ADDENDUM # 1

March 18, 2013

LIBRARY REMODEL FOR
BRIDGEPORT PUBLIC LIBRARY
BRIDGEPORT, NEBRASKA

Addendum- Arch Framing		
Project number	R-1712	Add-1a
Date	3/13/2013	
Drawn by	MJH	
Checked by	Checker	
Scale		1/4" = 1'-0"

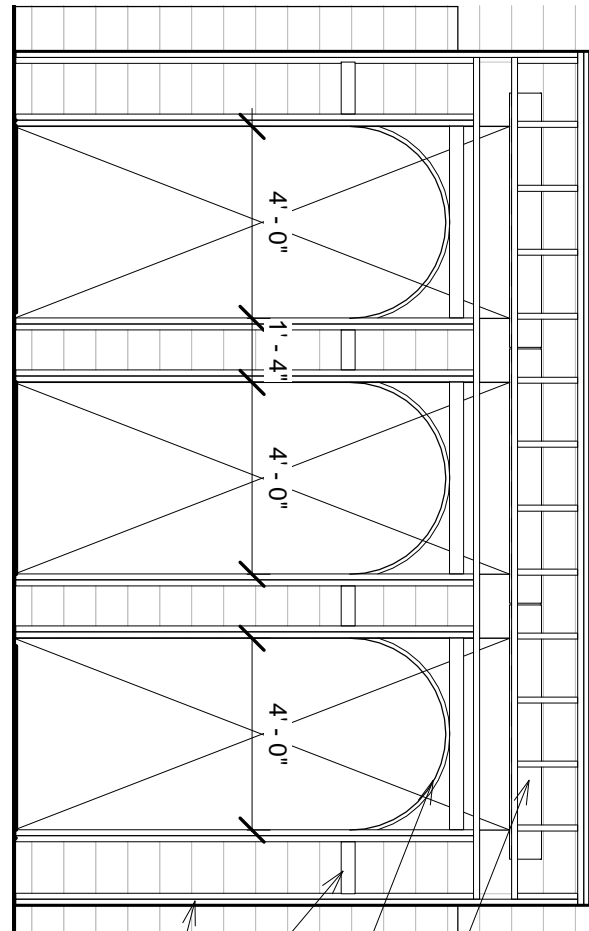
- Item No. 16: For clarification, sheet A320, section 2 calls for a structural angle. Each side shall have 3 angles, one above each arch. See Sheet Add-1a, Addendum- Arch Framing, for details (included with this addendum).
- Item No. 17: For clarification, Sheet A320, Drawings 5 and 6 shows a gray grid, which represents the existing block wall.

- (3) 5" X 5" X 3/8" ANGLE WITH MINIMUM BEARING 8" AT EACH END
- PREFABRICATED HALFROUND WOOD ARCH
- 2X4 FRAMING MEMBERS
- 2X2 FRAMING MEMBERS
